PINEGROVE UPDATE REPORT

Official Plan Amendment OPA24/012 and Zoning By-law
Amendment ZBA24/024 for 4611 King Street East.

PINEGROVE COMMUNITY ASSOCIATION
EXECUTIVE COMMITTEE
FEBRUARY 8, 2025

Figure 2 Rendering of the building form juxtaposed with current low rise residential community

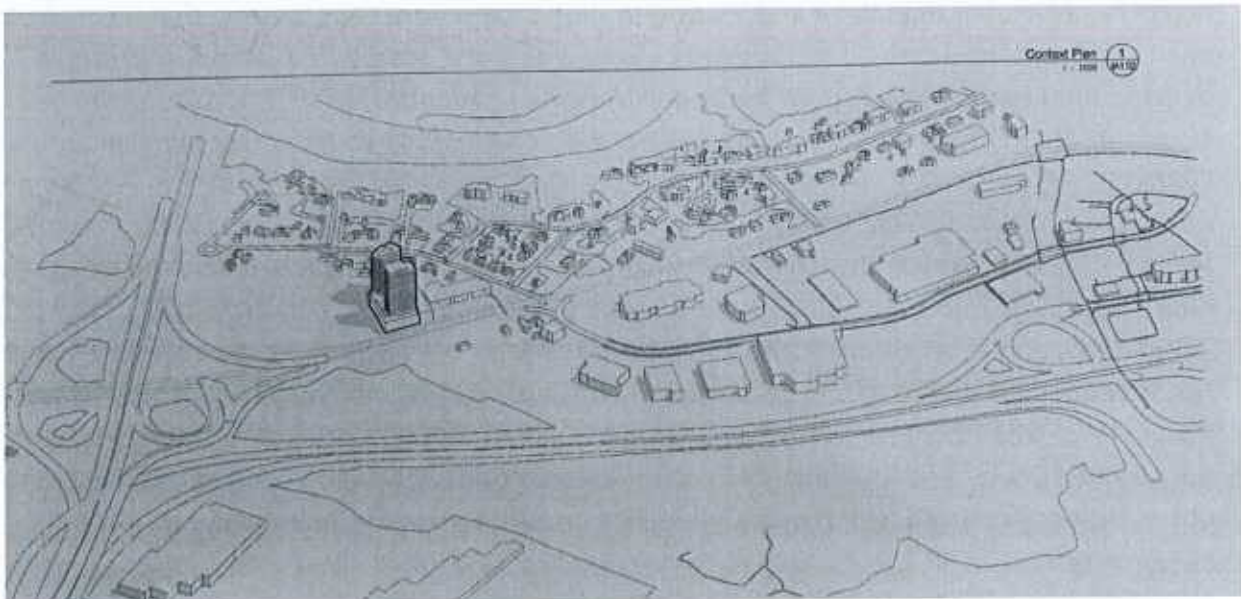
This proposed development will still loom much higher into the streetscape than is compatible with the existing low rise area even with recent modifications to the concept. The proposed heights are still significant taller than the 8 storey structures outlined for this type of zoning and employed in transition to low rise commercial at 4396 King Street East-Sportsworld Drive. This height is much taller than the 4 and 5 storey podiums in the zoning by-law and that have already been approved for nearby developments – ***why is a 6 or 7 storey podium appropriate in this development particularly when it backs onto low rise residential?*** {GSP Urban Design Brief 4611 King Street East, City of Kitchener Zoning By-law Amendment, June 2024; City of Kitchener DSD-2025-025 Official Plan Amendment Application; OPA24/012/K/ES Zoning By-law Amendment Application ZBA24/024/K/ES 4611 King Street East Imperial Oil Limited c/o LJM Developments, January 10, 2025} ***Why is the transition down to a 3 storey podium included on the side facing King Street East and that abutting MTO lands*** {City of Kitchener, DSD-2025-025, January 10, 2025} ***and not also required all the way around to form a transition to the adjacent low rise residential neighbourhood?*** The requested FSR is also significantly higher than the suggested maximum of 4 or 5 (when there is below-grade parking) in MIX-3 zoning. When weighed against the mounting number of other concerns around the proposed development on this site, there is not sufficient justification for many elements in outlined in the planning and urban design documents.

of lands covered under Growing Together East, the proposed development is one of the first, if not the first, development contemplated on lands on the south side of King Street East directly abutting the Pinegrove Community. As such, it is critical that this project is 'done right', hence the previous recommendation to work together to form a **Master Plan** for the area. If done in a well-considered fashion, this will indeed form the desired welcoming gateway to the City of Kitchener, whilst also acknowledging its proximity to an existing rural, low-rise neighbourhood. Even after the proposed reduction in tower height, however, the buildings and site layout suggest an inward focus, without clear attempt at drawing a welcoming connection to the surrounding neighbourhood(s). The tall "urban street" concept forwarded by this development is not conducive to presenting a welcoming gateway to the city, nor compatible with zoning outlined in Growing Together East and certainly not compatible with the existing low rise neighbourhood. The proposed buildings simply represent too large a step change in height and character, without sufficient setback or transition to integrate into their historic, rural surroundings on the Pinegrove Community side or to enhance the quality of the future planned streetscape and pedestrian realm presumably envisioned under Growing Together East along the south side of King Street East (see Figure 2).

Continuing development of similar nature along both sides of King Street East will result in a tunnelway rather than a vibrant, friendly entranceway into the projected East Growth Area. This nature of development would stick out as not coherent with the proposed streetscape along the same side of King Street East, and thus is much better suited to the north side of King Street East where higher development is project and both transit toward Kitchener and active transportation options are both inherently more accessible. With high density development along only one side of King Street East, the tunnel effect seen on streets lined with high density development along both sides would be avoided. In addition, King Street would provide a natural buffer zone that aids the intent of designing with setbacks and transitions from high intensity development to adjacent residential neighbourhoods such as Pinegrove. These good planning concepts are well developed in the current and pending Kitchener zoning and planning documents.
